VIRGINIA ELECTRIC AND POWER COMPANY
NORTH ANNA POWER STATION UNIT 1
ASME SECTION XI RELIEF REQUESTS NDE-9 AND NDE-15

Request for Additional information

ASME Section XI Relief Request NDE-9

Additional Information for Relief Request NDE-9, Revision 1

Figure 1
Flaw location

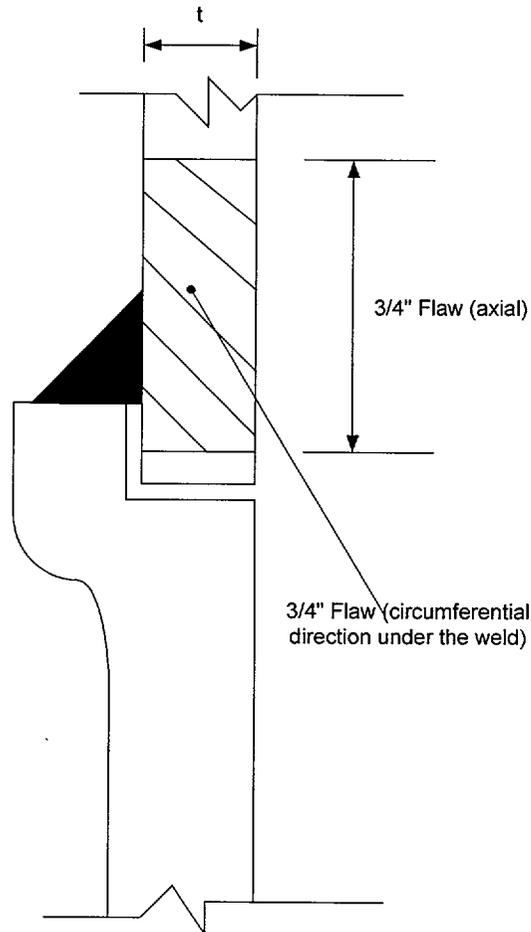
Provide the results of the failure analysis for the flaws associated with MIC in the SW System and a characterization of the flaw

There have been approximately 102 suspected MIC locations repaired in service water piping since 1996. Forty-five of the locations have been associated with socket welded piping and the balance with butt welded piping. Twenty-six suspected MIC locations have been examined by the failure analysis laboratory. Of these, nine were associated with socket welded piping and 17 with butt welded piping. For five of the socket weld locations, the lab was unable to identify an actual leak location or any evidence of MIC. For the other four, MIC pits with maximum extents ranging from about 0.06 to 0.251 inches were found. In the case of the 17 butt welds, pits with extents ranging from about 0.125 to about 0.562 inches were found. Refer to the Table, "Service Water MIC Pit Sizing," on the next page for details. In addition, although we have not documented in a formal inspection, discussions with inspection personnel indicate that where active leakage was identified, the leak appeared to be in base metal at or near the toe of the weld as opposed to actually penetrating the weld metal itself. Based on the results of failure analysis, MIC attack that results in leakage appears to grow in subsurface extent to no more than about 2.5 times the wall thickness of the affected pipe. Therefore, based on a maximum expected pipe wall thickness of about 0.173 inches (manufacturer's minimum plus 12.5%) for a 2 inch Standard schedule pipe (used in the service water system), it was determined that a 3/4 inch assumed flaw in socket welded pipe would bound any expected degraded condition (Figure 1).

Figure 2
Circumferential Flow

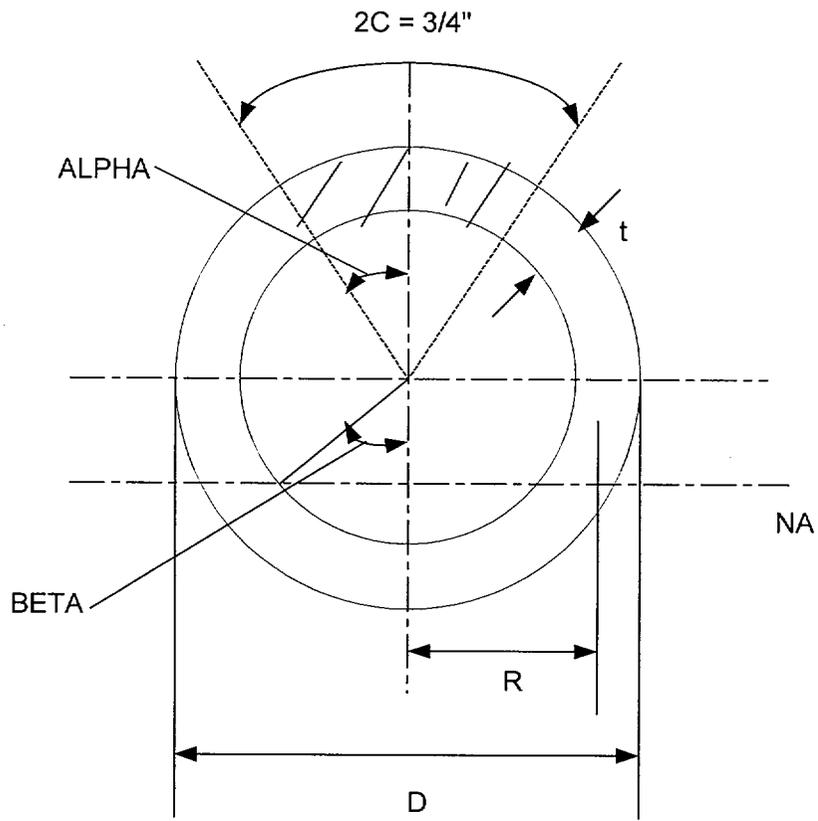
Structural analysis methodology for MIC flaw in vicinity of socket weld.

Based on the anticipated enveloping flaw on the small-bore ($\frac{3}{4}$ " - 2") piping in the vicinity of a fillet weld, the flaw will be modeled for analysis as follows:

- i) A $\frac{3}{4}$ " long through-wall circumferential flaw (Fig 2).
- ii) A $\frac{3}{4}$ " long through-wall axial flaw (Fig 3).
- iii) A $\frac{3}{4}$ " diameter hole.

The analysis will be performed using the guidance from the ASME Code Case N-513 and ANSI B31.1 Power Piping Code paragraph 104.3. The analysis will treat the flawed location as equivalent to the nominal pipe of the same size containing the enveloping flaw. The required margins in the Code Case will be demonstrated using the loadings due to pressure, deadweight, thermal expansion, seismic OBE and DBE conditions as appropriate. A residual stress equal to the yield stress in the material will be used in the analysis to address the influence of the weld. The $\frac{3}{4}$ " hole will be evaluated using the area replacement method of the ANSI B31.1 Code.
